Tyler Nature Center- ADA Evaluation

WMA- Tyler Nature Center, Tyler TX, ADA Evaluation

Accessibility Evaluation

Inspection Date: 11/16/2022

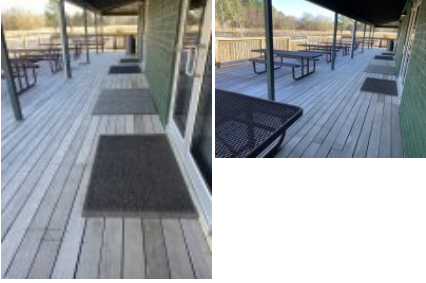
Finding Number	Area Description	Finding	As Built	Recommendation	Citation	Photos	Figure
1	Exterior of Property (Public): Public Entrance- Main Building Parking Lot (4 Spaces) 3 Van 1 Car - Van Accessible Stall (Far (R) Side)	The cross slope (narrow dimension) of the parking stall exceeds 2%. The running and cross slope in an accessible parking stall and the access aisle must not exceed 2%.	Back left corner of parking stall cross slope 5.9%	https://www.access-board.gov/ada/#ada-502_4	2012 TAS Section: 502.4 2010 ADAS Section: 502.4 2015 ABAAS Section: 502.4		
2	Exterior of Property (Public): Parking Lot- After Hours (3 Spaces) 2 Van 1 Car - All Accessible Stalls (2 Van 1 Car)	Signage is partially blocked by tree branches for 2 of the 3 parking spaces.	N/A	Manage tree branch obstructions to improve access.	2012 TAS Section: Recommended 2010 ADAS Section: Recommended 2015 ABAAS Section: Recommended

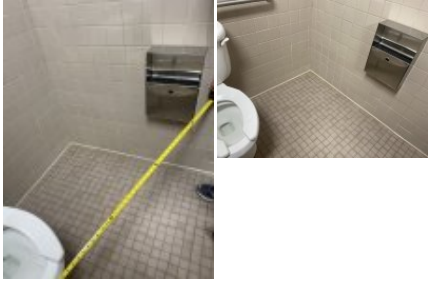
Finding Number	Area Description	Finding	As Built	Recommendation	Citation	Photos	Figure
4	Structures on Property (Public) : Public Spaces- Main Building (Interior) - Water Fountains	The water fountain has been found to be in substantial compliance with accessibility codes, standards, and regulations.	Need a better photo	N/A	2012 TAS Section: Advisory 2010 ADAS Section: Advisory 2015 ABAAS Section: Advisory		
5	Structures on Property (Public) : Visitors Center (Exterior)	The clear floor space required at the element is not flat (2% or 1:48 maximum slope) in all directions. Changes in level are not permitted at required clear floor or ground space except that slopes not steeper than 1:48 shall be permitted.	Ratio of compliant picnic tables satisfied. Few infractions include, deck sloping pictured exceeds 2% tolerance and floor mats look worn and should be replaced.	https://www.access-board.gov/ada/#ada-305_2 https://www.access-board.gov/ada/#ada-302_2	2012 TAS Section: 305.2 2010 ADAS Section: 305.2 2015 ABAAS Section: 305.2

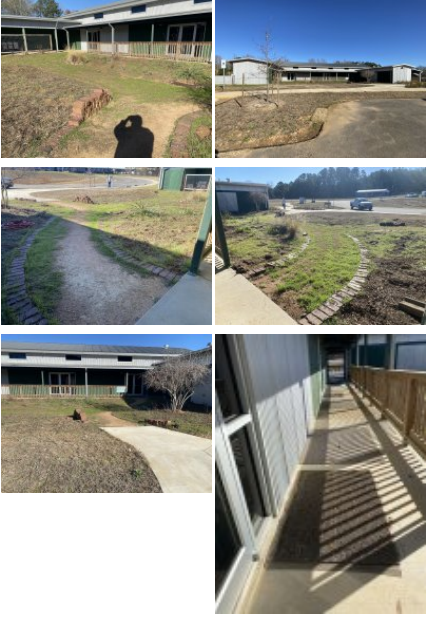
8	Structures on Property (Public) : Visitors Center (Exterior) - Restroom (Men's)	The door exceeds the maximum allowable opening force. Interior doors shall have a maximum opening force of 5 pounds. These forces do not apply to the force required to retract latch bolts or disengage other devices that hold the door or gate in a closed position.	Door requires more than 5lbs pressure to open. The ADA Standards do not specify the opening force for exterior doors, though some state and local building codes may have requirements. Typical maximum opening force for exterior doors ranges from 8.5 to 10 lbs	https://www.access-board.gov/ada/#ada-404_2_9	2012 TAS Section: 404.2.9 2010 ADAS Section: 404.2.9 2015 ABAAS Section: 404.2.9

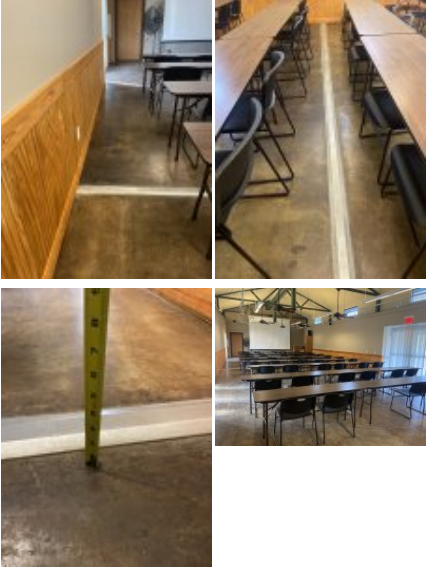
Finding Number	Area Description	Finding	As Built	Recommendation	Citation	Photos	Figure
9	Structures on Property (Public) : Visitors Center (Exterior) - Restroom (Men's)	The ambulatory compartment is missing a loop handle on one side of the door. The door to the ambulatory stall shall be self-closing. A door pull shall be placed on both sides of the door near the latch. Toilet compartment doors shall not swing into the minimum required compartment area.	N/A	https://www.access-board.gov/ada/#ada-604_8_2_2	2012 TAS Section: 604.8.2.2 2010 ADAS Section: 604.8.2.2 2015 ABAAS Section: 604.8.2.2		
10	Structures on Property (Public) : Visitors Center (Exterior) - Restroom (Men's)	The toilet paper is not installed within the compliant range. Toilet paper dispensers shall be 7 inches minimum and 9 inches maximum in front of the water closet measured to the centerline of the dispenser. The outlet of the dispenser shall be 15 inches minimum and 48 inches maximum above the finish floor and shall not be located behind grab bars. Dispensers shall not be of a type that controls delivery or that does not allow continuous paper flow. There shall be a clearance of 1 1/2 inches minimum below the grab bar.	TP dispenser mounted too close.	https://www.access-board.gov/ada/#ada-604_7	2012 TAS Section: 604.7 2010 ADAS Section: 604.7 2015 ABAAS Section: 604.7

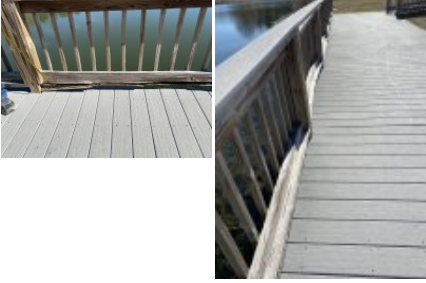
14	Structures on Property (Public) : Visitors Center (Exterior) - Restroom (Women's)	The threshold has a vertical change greater than 1/4 inch. The threshold at a doorway shall be no higher than 1/2 inch. Changes in level between 1/4 inch and 1/2 inch must be beveled at 1:2 or less. The maximum vertical rise shall be 1/4 inch.	N/A	https://www.access-board.gov/ada/#ada-404_2_5	2012 TAS Section: 404.2.5 2010 ADAS Section: 404.2.5 2015 ABAAS Section: 404.2.5

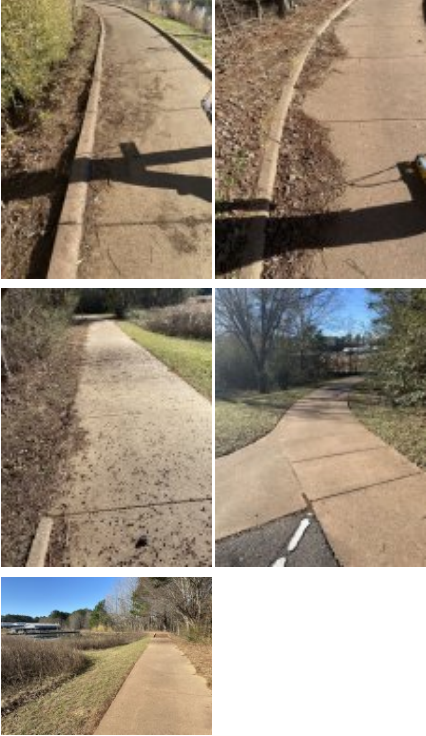
Finding Number	Area Description	Finding	As Built	Recommendation	Citation	Photos	Figure
24	Outdoor Features (Public) : Fishing Pier (Visitor Center) - Pathway to Pier (Ramp)	The ramp does not have compliant handrails. Handrails are required on both sides of all surfaces that are sloped greater than 5 percent (1:20). Handrails must be between 34 inches and 38 inches above the ramp surface, must extend 12 inches beyond the top and bottom of the ramp and be parallel to the floor or ground surface. The diameter of the handrails must be between 1 1/4 inches and 2 inches in cross-sectional nominal dimension for circular handrails. Handrail gripping surfaces with a non-circular cross section shall have a perimeter dimension of 4 inches minimum and 6 1/4 inches maximum, and a cross-section dimension of 2 1/4 inches maximum. The space between handrails and walls must be 1 1/2 inches minimum.	Ramp requires compliant handrails.	Review handrail componets to make accessible https://www.access-board.gov/aba/#aba-505_1	2012 TAS Section: 505.1 2010 ADAS Section: 505.1 2015 ABAAS Section: 505.1

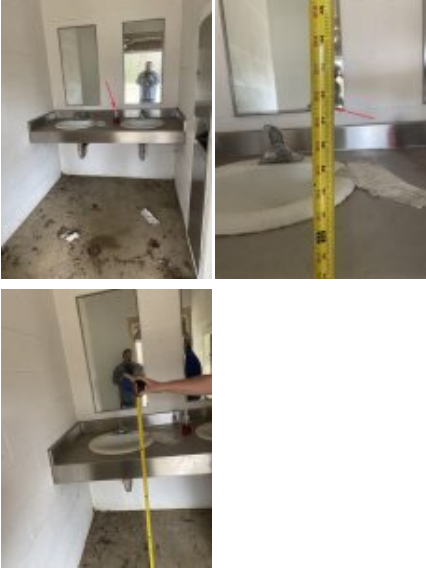
Finding Number	Area Description	Finding	As Built	Recommendation	Citation	Photos	Figure
29	Outdoor Features (Public) : Nature Trail #1 (Around Fishing Pond)	There are obstacles on the trails, passing spaces, and resting intervals that exceed 1/2 inches in height Tread obstacles on trails, passing spaces, and resting intervals shall not exceed 1/2 inch in height measured vertically to the highest point.	Trail componets are compliant but needs to remain debris free	Trail meets ADA compliance when clear of debris.	2015 ABAAS Section: 1017.5		
30	Outdoor Features (Public) : Nature Trail #1 (Around Fishing Pond)	The cross slope of the surface of the trail exceeds the maximum. The cross slope shall be not be steeper than 1:48.	Portion of trail from overnight parking to pier has cross slope exceeding 2.0%	N/A - Refer to Finding	2015 ABAAS Section: 1017.7.2

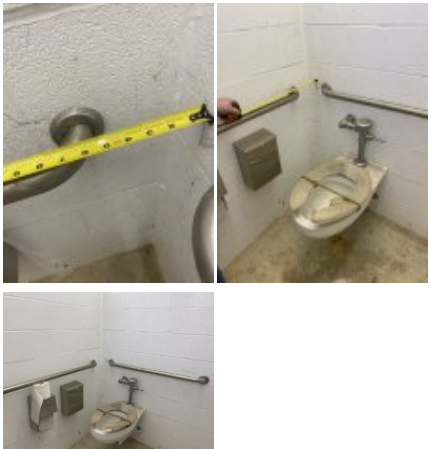
Finding Number	Area Description	Finding	As Built	Recommendation	Citation	Photos	Figure
31	Outdoor Features (Public) : Nature Trail #2 (Pavilion/ Restrooms)	The trail is missing the trailhead sign. Where new trail information signs are provided at trailheads on newly constructed or altered trails designed for use by hikers or pedestrians, the signs include the following: 1. Length of the trail or trail segment; 2. Surface type; 3. Typical and minimum tread width; 4. Typical and maximum running slope; and 5. Typical and maximum cross slope.	Trail provides some access but missing componets for full compliance including accessible trail head. Trail from fishing pier to outdoor pavilion and restroom.	Provide trail head sign listing accessibility levels as best practice.	2015 ABAAS Section: F216.13		
32	Outdoor Features (Public) : Nature Trail #2 (Pavilion/ Restrooms) - Pavilion #2 (Trail)	The surface of the outdoor recreation access route, passing spaces, and/or resting intervals are not firm and stable. The surface of outdoor recreation access route, passing spaces, and resting intervals shall be firm and stable	Route from restroom to pavilion and trail to pavilion features some accessible componets but overgrowth/sloping prevents access.	N/A - Refer to Finding	2015 ABAAS Section: 1016.2

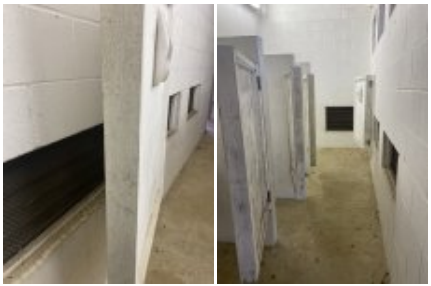
35	Outdoor Features (Public) : Nature Trail #2 (Pavilion/ Restrooms) - Restroom (Men's)	The water closet compartment is missing a loop handle on both sides of the door. Water closet compartments must be equipped with a door that has a loop or U-shaped handle on both sides of the door immediately below the latch. The latch must be flip-over style, sliding or other hardware not requiring the user to grasp or twist.	No handles	https://www.access-board.gov/ada/#ada-604_8_1_2	2012 TAS Section: 604.8.1.2 2010 ADAS Section: 604.8.1.2 2015 ABAAS Section: 604.8.1.2

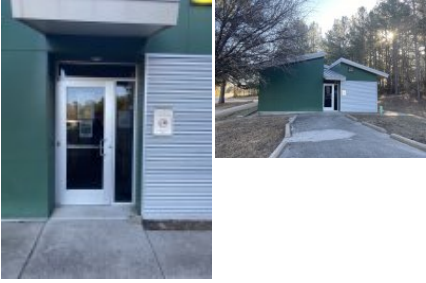
Finding Number	Area Description	Finding	As Built	Recommendation	Citation	Photos	Figure
44	Exterior of Property (STAFF): Staff Parking Lot (4 Spaces) 2 Van 2 Car - Car Accessible Stall (Far (R) Side)	The stripe is missing at the right side of the right parking stall which identifies its border. Vehicle spaces shall be marked to define the width, and shall have an adjacent access aisle.	Border (R) side missing for accessible parking.	Accessible stall border is a curb- recommend painting the ground next to the curb. The width of the space can be taken all the way up to the curb. Low priority when compliant width of stall is provided.	2012 TAS Section: 502.2 2010 ADAS Section: 502.2 2015 ABAAS Section: 502.1, 502.2		
45	Exterior of Property (STAFF): Staff Parking Lot (4 Spaces) 2 Van 2 Car - Pathway to Building (Staff Parking to Staff Entrance)	The handrail extension is not a minimum 12 inches. Handrails must be between 34 inches and 38 inches above the ramp surface and must extend beyond the top and bottom of the ramp run 12 inches horizontally. The 12 inches horizontal extensions must not include the radius at the top end of round handrails. Extensions shall return to a wall, guard, or the landing surface, or shall be continuous to the handrail of an adjacent ramp run.	Handrails are missing extensions. ramp slopes, landings, and surface material are compliant. Exterior pathway leading to staff entrance compliant.	https://www.access-board.gov/ada/#ada-505_10_1	2012 TAS Section: 505.10.1 2010 ADAS Section: 505.10.1 2015 ABAAS Section: 505.10.1

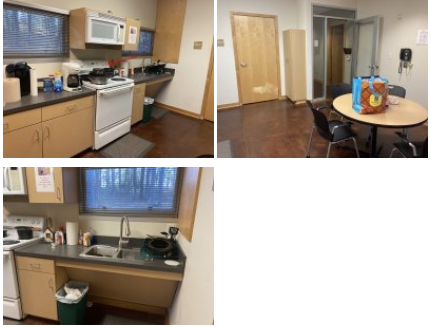
54	Structures on Property (STAFF): Regional Offices-Fishing (Interior) - Restroom (Men's)	The threshold has a vertical change greater than 1/4 inch. The threshold at a doorway shall be no higher than 1/2 inch. Changes in level between 1/4 inch and 1/2 inch must be beveled at 1:2 or less. The maximum vertical rise shall be 1/4 inch.	N/A	https://www.access-board.gov/ada/#ada-404_2_5	2012 TAS Section: 404.2.5 2010 ADAS Section: 404.2.5 2015 ABAAS Section: 404.2.5
